TOWN OF UNDERHILL

Development Review Board

VRV LIVING TRUST
SKETCH PLAN REVIEW
Docket #: DRB-20-10

Project Proposal: Sketch Plan Review of VRV Living Trust for a proposed 2-lot subdivision of property located at the aforementioned address.

SECTION 3.18 – STEEP SLOPES

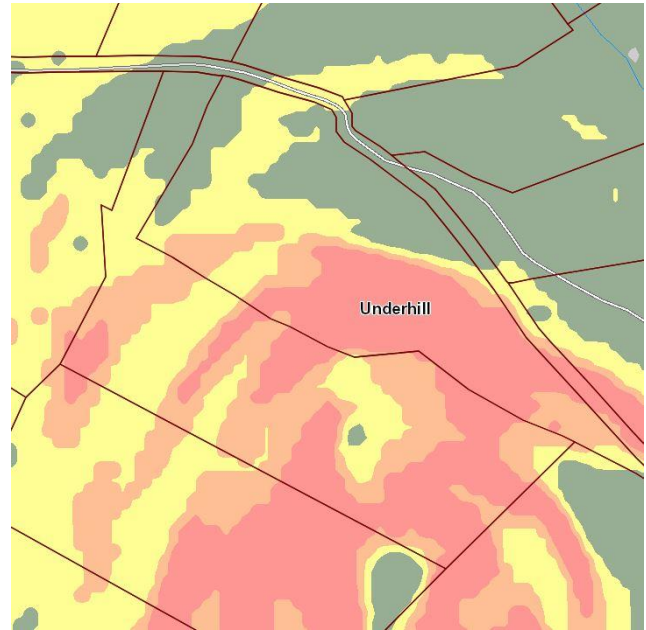
- Areas of steep slopes (15-25%) and very steep slopes (>25%) are present on the existing lot, as depicted by the Agency of Natural Resources.
- In 2018, the Applicant submitted documentation that better defined the steep slopes on the property (see Exhibit I).
 - The proposed dwelling lot on the proposed Lot 2 appears to be an area that does not contain steep slopes; however, the driveway may impact steep slopes, thus requiring review similar to the previous application (see DRB-18-14).
 - The Board performed a similar review relating to the impact to steep slopes for the construction of the existing driveway – see Exhibit G.
- No additional impact other than what has been presented appears to be proposed.

SECTION 8.3.F – FARMLAND

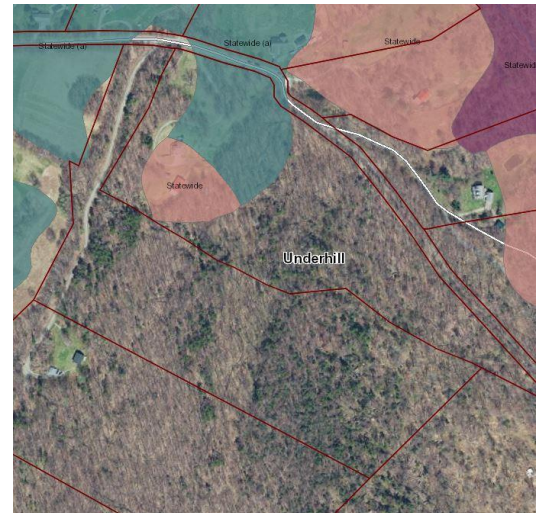
- A small area of prime agricultural soils near Grant's Landing (see directly to the right) exists on the lot, but does not appear as though it will be impacted.
